2006 AKA MANUAL

ADDENDUM No.29

Issued: 30 March 2006

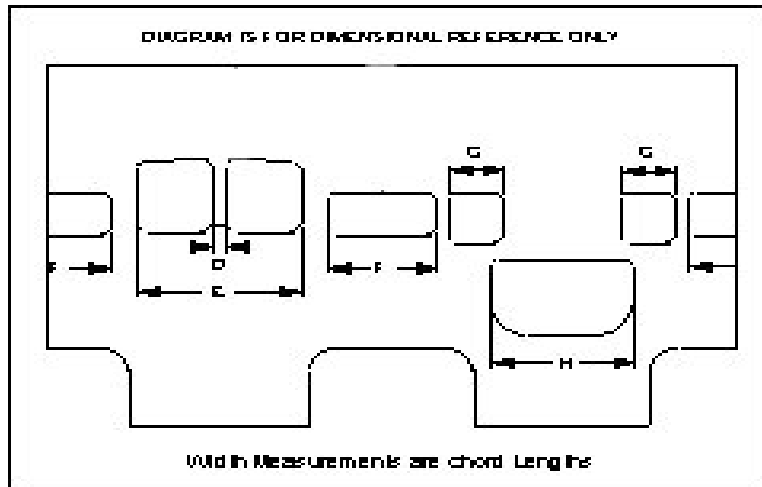
On the NKC telephone conference held on 29 March 2006, approval was given for the following amendment to Chapter 34 – Rule 34.14, specifically in reference to the Engine Splits for Yamaha S.

34.14 Exhaust, Intake and Transfer Ports:

All ports are to be in an “as cast” condition Refer to 34.16

CODE	DIMENSION	CODE	DIMENSION
C	3.40 mm min	D	39.60 mm max
E	26.15 mm max	F	13.34 mm max
G	34.80 mm max

Port Split 9.50mm minimum, exhaust to transfer.
